## STAFF REPORT

**Case # 02-17: SITE PLAN REVIEW**

NW corner of Church  
and Chaffee Streets

This is a request by applicant for Site Plan approval under Chapter 9 Comprehensive Zoning §5400 for new construction of the 5,200+/- SF Xcel Brazilian Jiu Jitsu Gymnasium located at the NW corner of Church and Chaffee Streets (Map 130G-1, formerly known as Lots 22 and 41-44) on a 27,871 SF site in the Industrial A (IA) zoning district.

**SHEET NO.**  
**A-1.1**

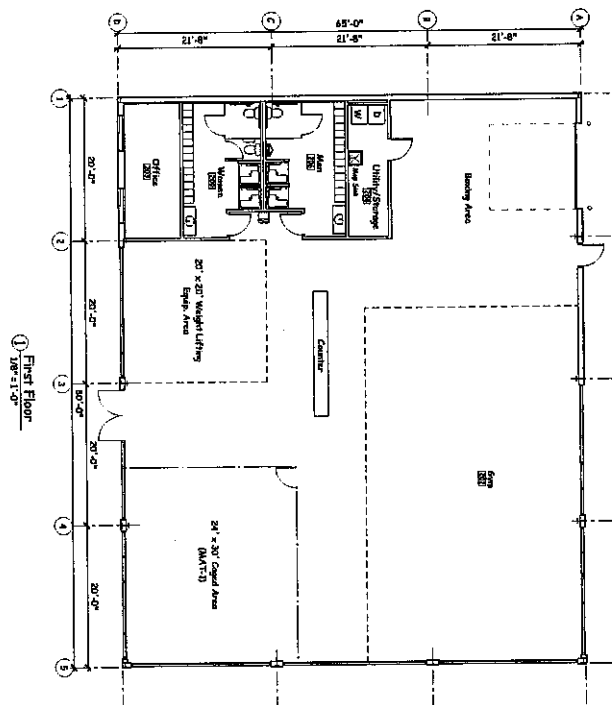
- Number of Stories has been omitted.
  - There is an overhead door shown on the Elevation drawing sheet No. A-1.1 at the north elevation that is not illustrated on the layout plan.

## LAYOUT & LANDSCAPE PLAN

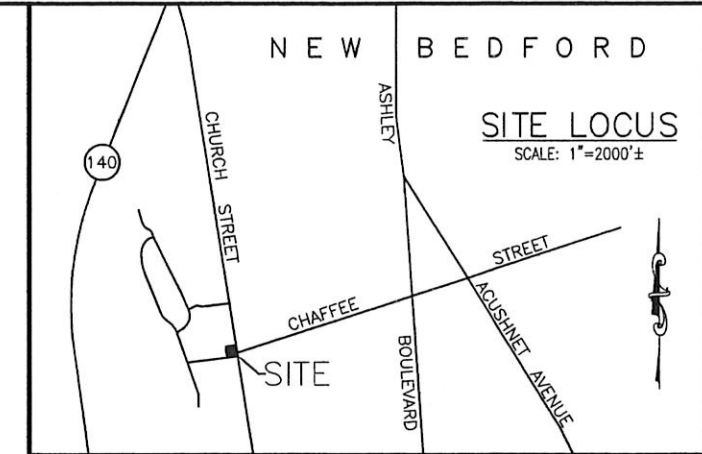
- Pavement type is not noted on plan.
  - It is assumed lighting is wall pack. Staff recommends that applicant provide cut sheets for review and approval by Planning Board or City Planner.

- **Landscape Plan**, as stipulated on Site Plan Review Checklist (Applicant has combined Layout and Landscape plan)
- Landscape details omitted. The Planning Board will require a Landscape Plan and planting schedule, as stipulated under Municipal Code (Section 5451.e.)

5. Add 3 trees to the Chaffee St. sidewalk area.
6. This site plan includes 5 different lots. Owner to provide copy of recorded plan for combining the parcels.

GRADING & UTILITIES PLAN  
XCEL BRAZILIAN JIU JITSU  
MAP 130G-1, FORMERLY LOTS 22, 41-44  
NEW BEDFORD, MASSACHUSETTS

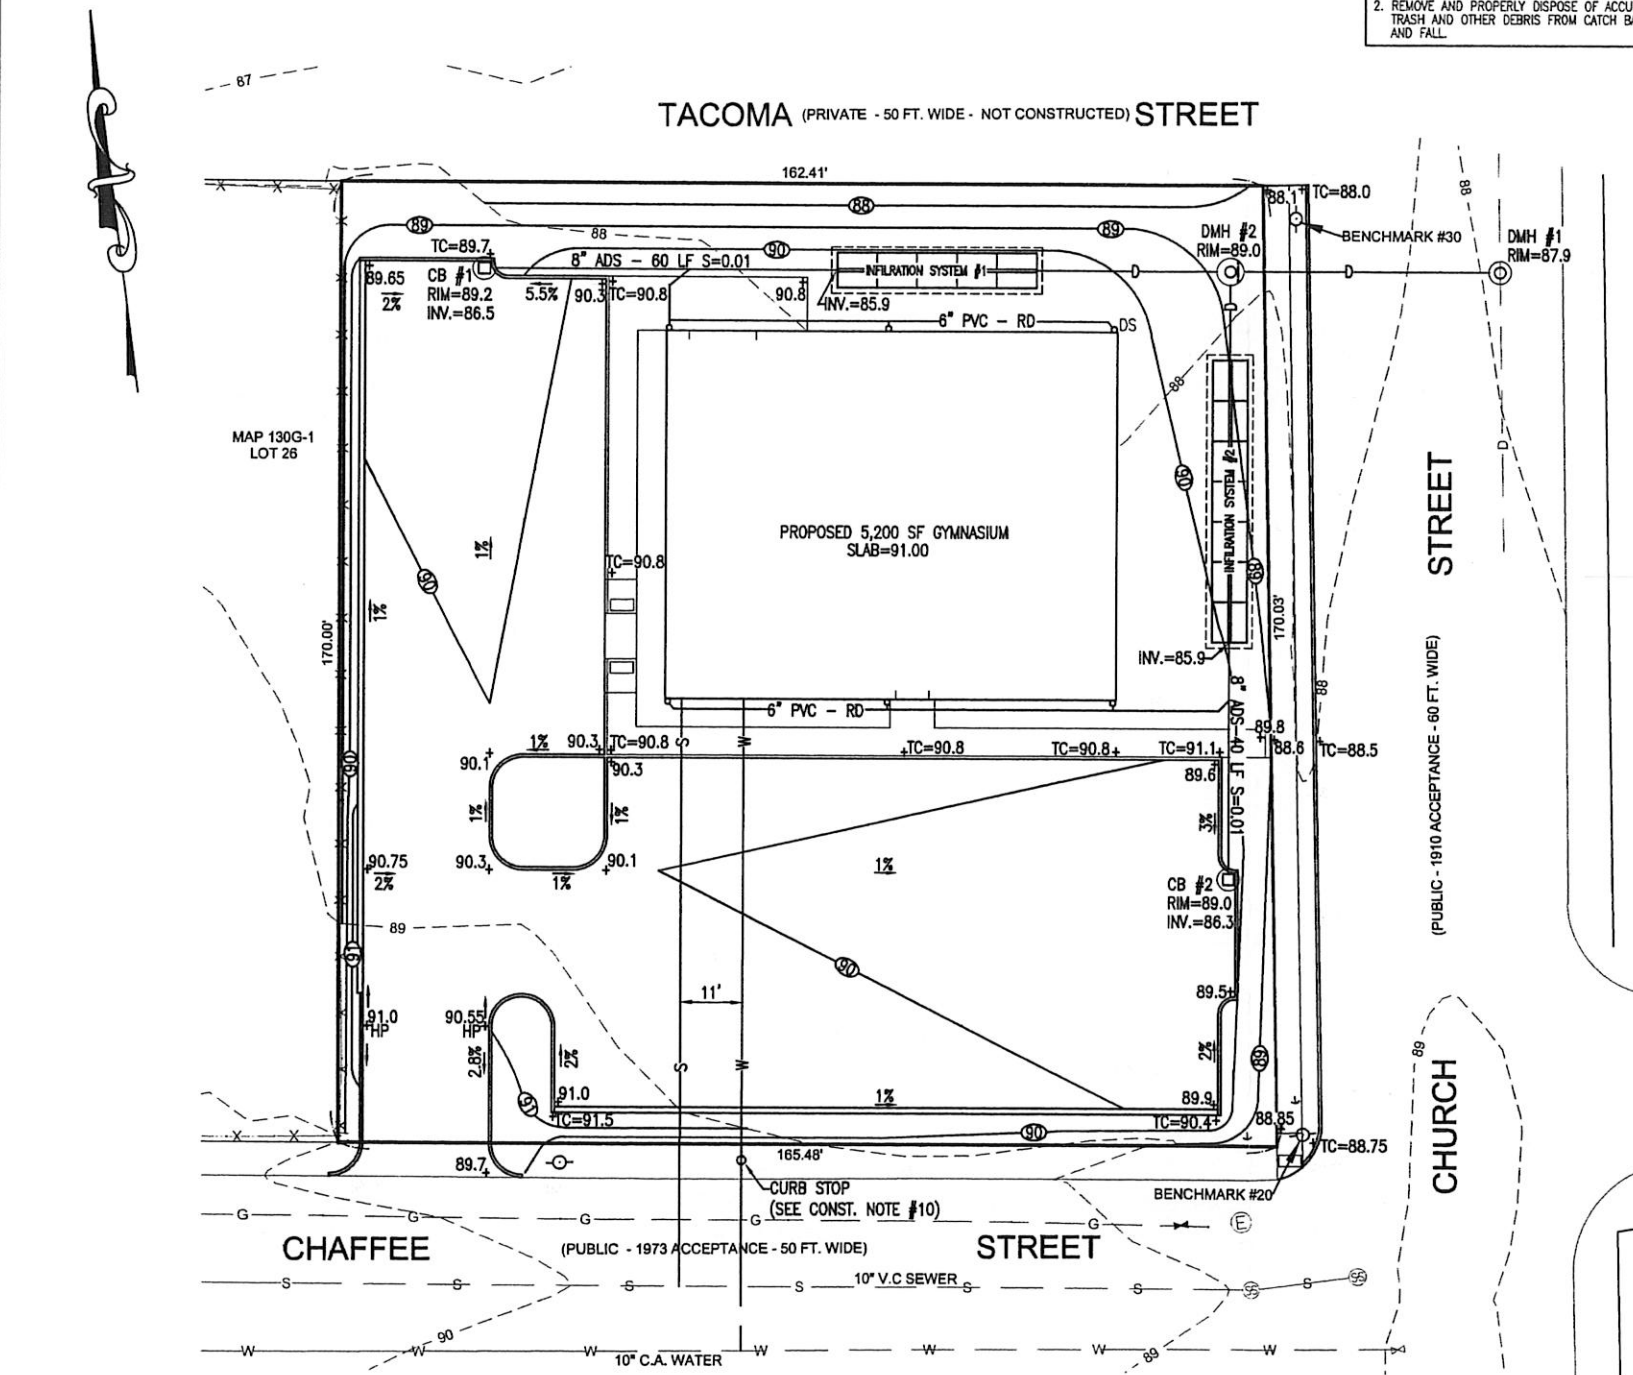
- Add Note: The contractor shall obtain a Street Disturbance & Obstruction Permit prior to any construction within the right-of-way
  - Add Note: All water and sewer material and construction shall conform to the City of New Bedford requirements

- Add Note: All water and sewer construction shall be inspected by the City Of New Bedford before being backfilled
  - Add Note: The City shall be notified at least 24 hours prior to the required inspections
